# Special Bulletin

# SP15-340

## SWAY BAR CLAMP HARDWARE REPLACEMENT

Prevost vehicles

Figure 2

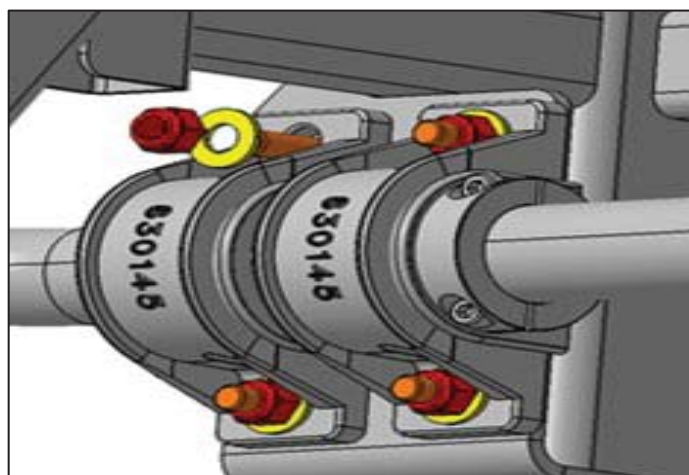
Remove and discard old hardware and replace with new bolts, nuts and washers one at a time. (fig. 2)

Tightening must be done two times (lower bolt , upper bolt, lower bolt , upper bolt)

Torque to **90lbf-ft**

Apply Valvoline corrosion protection on hardware after tightening.

Figure 3

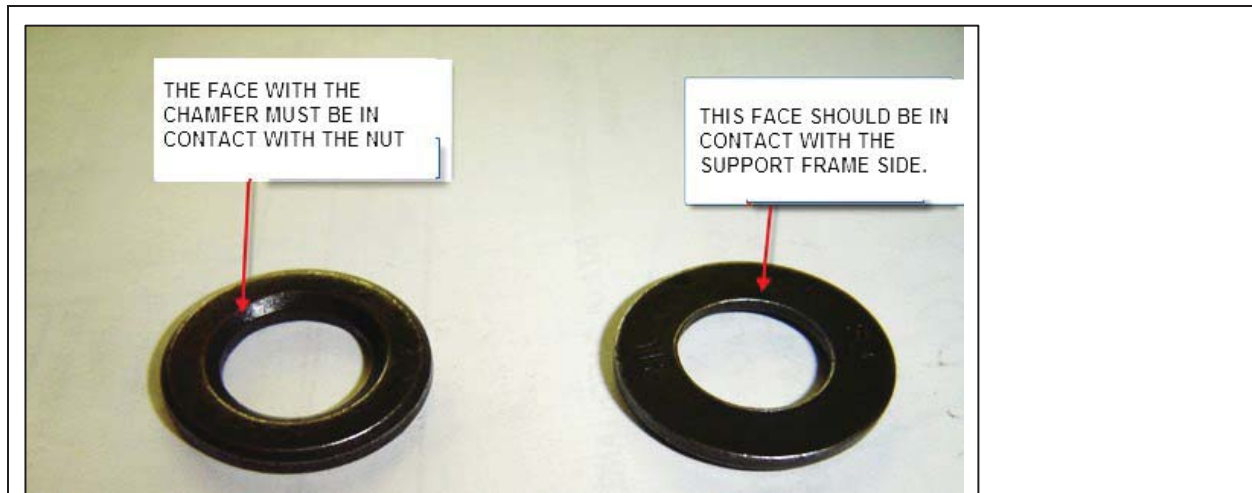
Confirm proper washer orientation before tightening. See fig. 3.

*All surfaces in contact with washer must be **clean and dry**.*
